SAFETY EVALUATION BY THE OFFICE OF NUCLEAR REACTOR REGULATION  
RELATED TO AMENDMENT NO. 236 TO FACILITY OPERATING LICENSE NO. DPR-58  
AND AMENDMENT NO. 218 TO FACILITY OPERATING LICENSE NO. DPR-74

DONALD C. COOK NUCLEAR PLANT, UNITS 1 AND 2

DOCKET NOS. 50-315 AND 50-316

FIGURE 1 SCHEMATIC DIAGRAM OF D. C. COOK UNITS 1&2 PRIMARY LOOP SHOWING WELD LOCATIONS

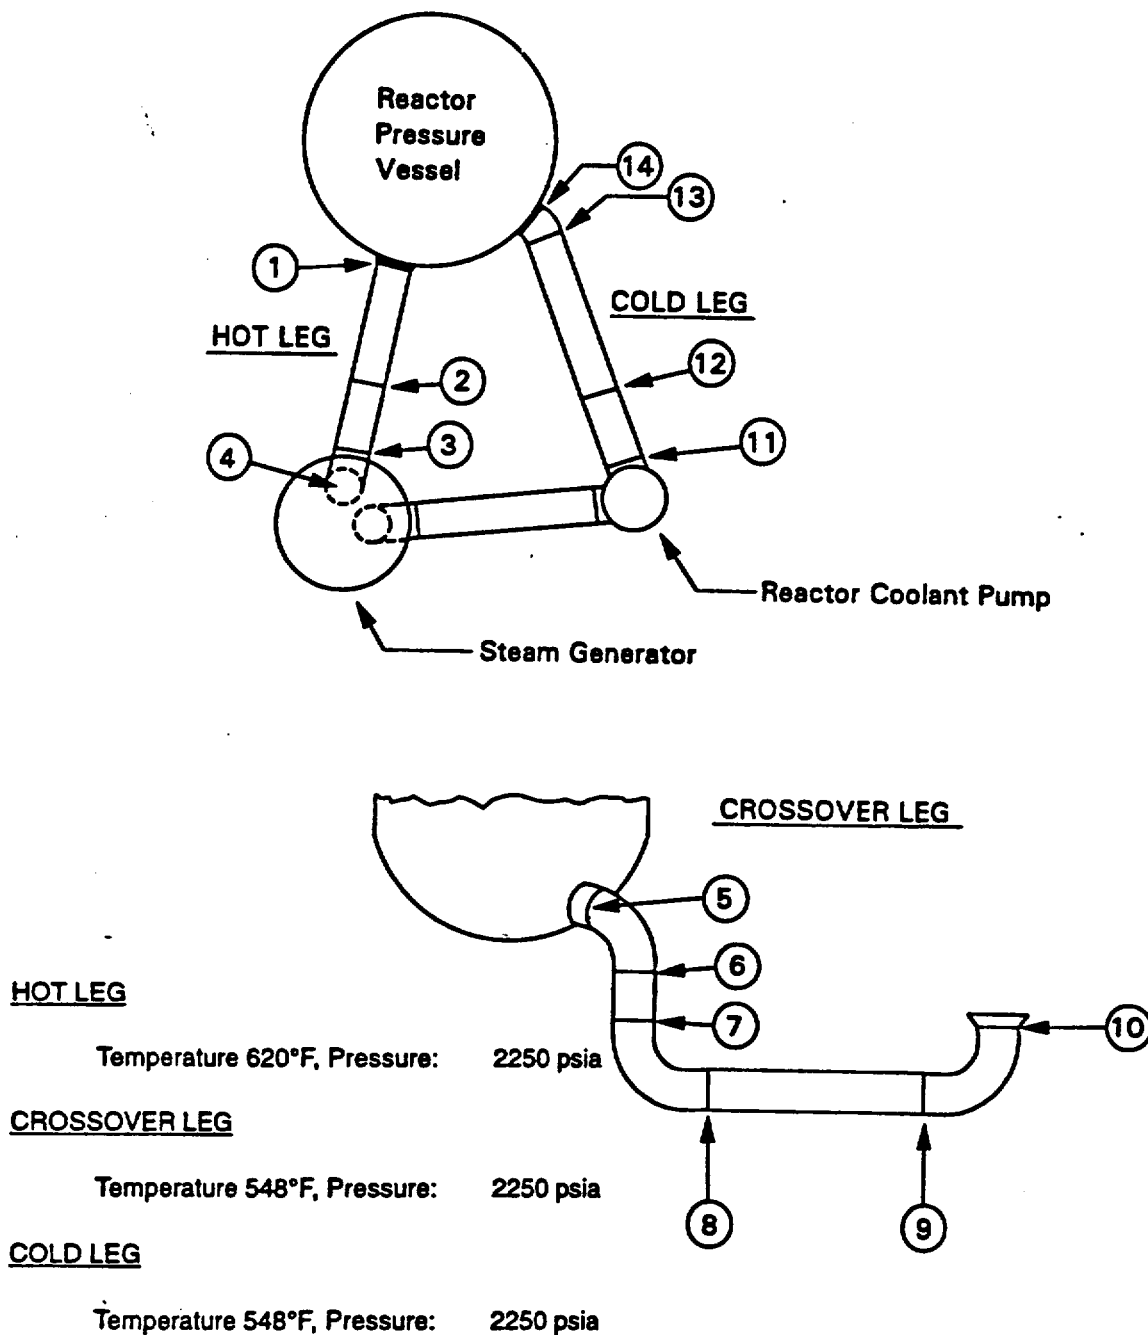
Next, the licensee determined the appropriate loading conditions to be used for the analysis. The licensee calculated the total piping stress at the fourteen locations identified in Figure 1 from the algebraic sum of the forces and moments due to deadweight, thermal expansion, and pressure loads during normal 100 percent power operation. These loads, herein called the "NOP" loads, along with the corresponding pipe dimensions at the fourteen locations, are given in Table 1. The licensee then calculated the total piping stress at the fourteen locations from the absolute sum of the forces and moments due to deadweight, thermal expansion, pressure loads during normal 100 percent power operation, and SSE inertial and anchor motions. These loads, herein called the "NOP+SSE" loads, for each location are given in Table 2. Based on an

evaluation of these loads, the licensee determined that the limiting locations for the LBB analysis would be locations 1, 10, and 11, as shown in Figure 1.

The staff's evaluation then examined the loadings submitted by the licensee. It was noted that the summation methodology utilized by the licensee was not completely consistent with the guidance provided by the staff in NUREG-1061 Volume 3 or Draft Standard Review Plan (DSRP) 3.6.3 for determining loads for LBB analyses. The inconsistency in the licensee's analysis was that the licensee did not include the torsional moments (as directed to in NUREG-1061 Volume 3). However, the licensee subsequently provided those moment components for each piping location in a letter dated November 19, 1999, so that information was available for the staff's evaluation. Based on the staff's evaluation of the loadings supplied by the licensee, the staff concluded that the limiting locations for the MCL piping evaluation would be location 1 (at the hot leg nozzle connection to the reactor vessel), location 5 (at the SG outlet nozzle), location 10 (at suction nozzle of the RCP) and location 11 (at the discharge nozzle of the RCP) as shown in Figure 1.

At each location, the staff evaluated the critical and leakage flow sizes for the CSS material and the associated SMAW weld. The material properties assumed by the staff for the CSS and SMAW materials are shown in Tables 4 and 5 and the loads used in the staff's leakage flow and critical flow analysis (which include the torsional moments) are shown in Table 6. The staff applied the PICEP code using the nominal piping dimensions and a crack surface roughness of  $\epsilon = 0.0003$  inches. This procedure calculated a 10 gpm leakage flow size for each material. The critical flow size determined by using the LBB.ENG2 or LBB.ENG3 code as appropriate. The ratio of the critical-to-leakage-flow size was then determined for comparison to the recommended margin of 2 in NUREG-1061, Volume 3. These results are summarized in Table 7. Since the margin of 2 on the crack sizes was achieved for each location, the leakage flow was also shown to be stable given the absolute summation of the NOP and SSE loads (as calculated by the licensee plus the torsional loads included in the staff's analysis), and meets the margin on loading recommended by NUREG-1061, Volume 3.

Based on the information and analysis supplied by the licensee, the staff was able to independently assess the LBB status of the D.C. Cook Unit 1 and 2 MCL piping. The staff has concluded that it has been demonstrated that the LBB behavior of the MCL is covered by the analysis submitted by the licensee and the independent evaluation by the staff presented in this SE. Furthermore, the licensee should be permitted to credit this conclusion for eliminating the dynamic effects associated with the postulated rupture of these sections of piping from the D.C. Cook Unit 1 and 2 facility licensing basis, consistent with the provisions of 10 CFR 50, Appendix A, General Design Criteria 4, including credit for removing from consideration the acoustic loads that would be generated by a DEGB of the MCL when evaluating the ability to insert the RCCAs.
